UniversityCity Pedestrian Bridge•Contract # BT-904/ARI 73•Federal Project ID 434688-1-58-01
MCM # 2015-711

RE: NOI#001 - Pylon Location – Additional Services
Request for Equitable Adjustment REA-COR#006
MCM Letter Log. No. FIU#004

RE:NOI#001 - Pylon Relocation - Additional Services

**CHANGE ORDER 05
ADDITIONAL DESIGN PHASE SERVICES TO BE PROVIDED BY
FIGG BRIDGE ENGINEERS, INC.
FOR THE
UNIVERSITYCITY PROSPERITY PROJECT, BT-904
FOR
MUNILLA CONSTRUCTION MANAGEMENT
November 22, 2016**

Figure 2.10.4.B Clearances – Urban Arterials and Collectors (Curb and Gutter) ≤ 45 mph – Section through Bridge

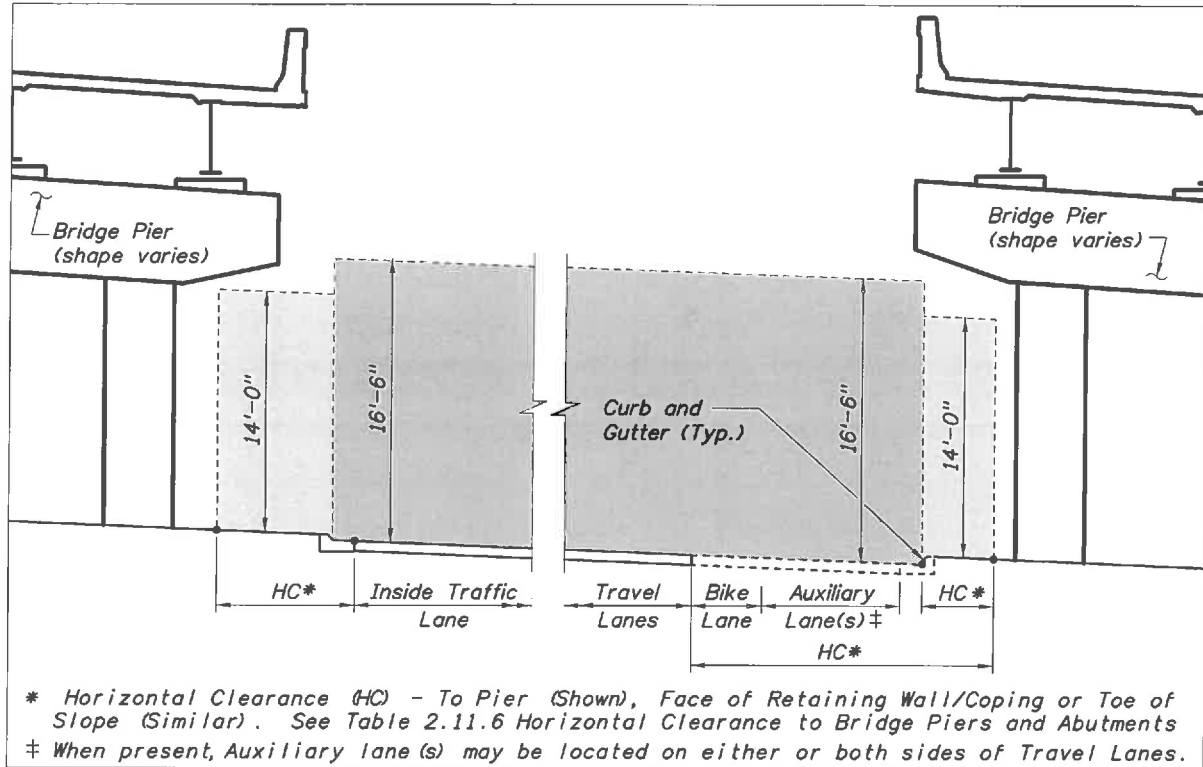
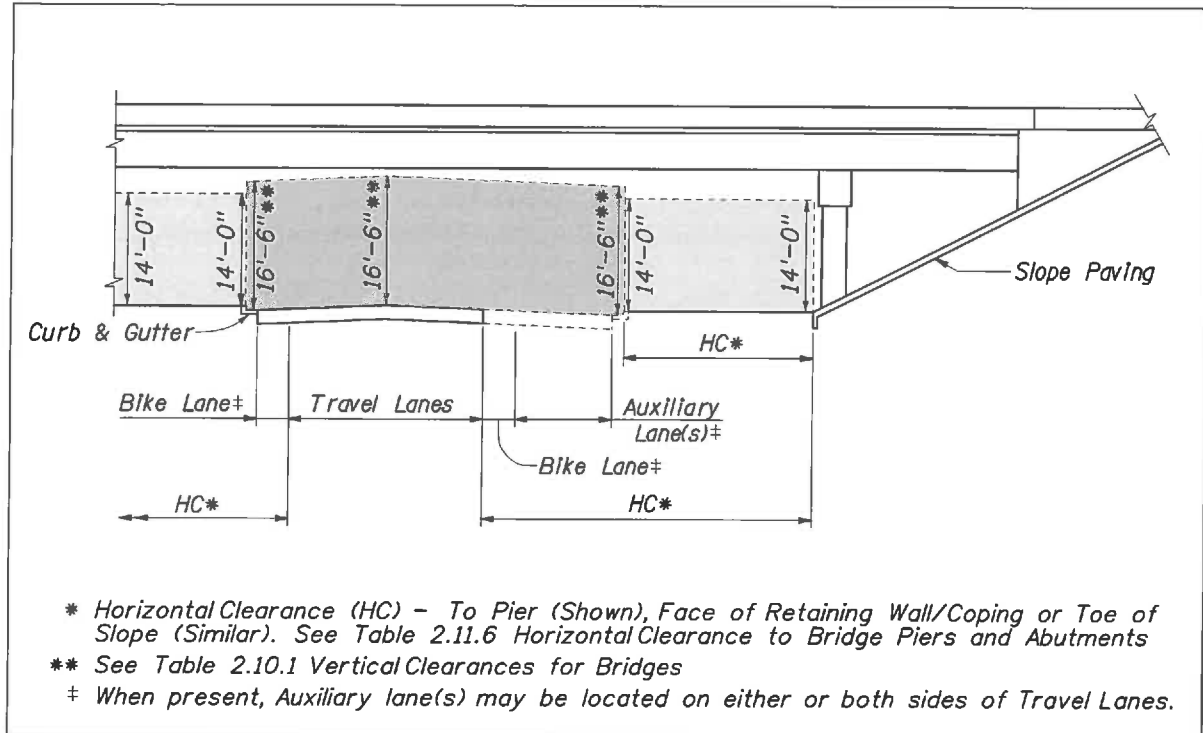
Per attachment 1, the reference of 16 foot clearance from edge of travel lane, this specific criteria is for Urban Roadways with Curb & Gutter and a speed limit of 45 MPH or greater. However, the location in question (Attachment 2) along S.W. 8th Street is an Urban Roadway with Curb & Gutter and a Roadside Barrier in which case PPM Table 2.11.6 states "use the minimum barrier offset as shown in Table 4.3.1 and Figure 2.10.5". As shown in Figure 2.10.5 and Table 4.3.1 when a roadside barrier is present, (existing guardrail) (Figure 1) which is the projects final condition, the minimum offset required by PPM criteria is 4 feet. Therefore, the current proposed design meets criteria per the 2014 PPM and Design Standards and no variation is required.

The minimum barrier offset as shown in **Table 4.3.1** measured from the face of the barrier.
See also **Figure 2.10.5**.
